TYPE III DEVELOPMENT & ENVIRONMENTAL REVIEW, STAFF REPORT & RECOMMENDATION

NORWAY GREEN SUBDIVISION

PLD2009-00049; SEP2009-00085; BLA2009-00033;

Request:

- Proposed Plot Plan
- List of Exhibits Received to Date

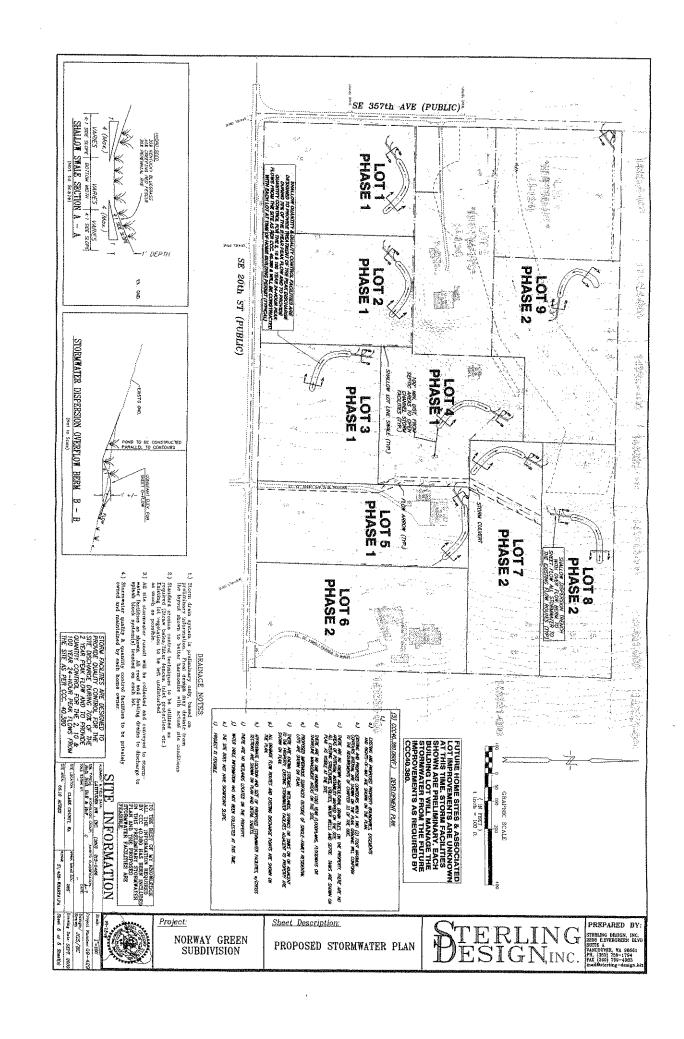
Staff visited the site on November 25, 2009 in order to verify the location of the stream. Staff observed a series of braided channels in the headwaters of the stream, as opposed to a single stream channel as shown on the preliminary plat. Staff used GPS to map the approximate location of the multiple channels.

Although the regulated stream covers more area than shown in the preliminary plat, the regulated 75-foot riparian zone is smaller than the 100-foot zone shown on the plat. Overall, these differences balance out so that the proposed building envelopes avoid the regulated area.

Proposed lots #4, #7, and #8 will take access from a proposed 30-foot wide joint driveway easement that is to provide access from SE 20th Street. At a minimum, the driveway shall be constructed from SE 20th Street to proposed lot #8 with a temporary turnaround. Proposed lot #9 will take access to SE 357th Avenue through an existing 30-foot private access and utility easement. The applicant has submitted information via an e-mail dated December 11, 2009 that states the easement does not restrict access from proposed lot #9. The remaining proposed lots will take access to the frontage roadways. (See Condition A-3a)

- D-2 The applicant shall clearly show building envelopes and habitat areas on the face of the final plat. Any revisions to the proposed building envelopes will require additional review. (See Findings 5 and 6)
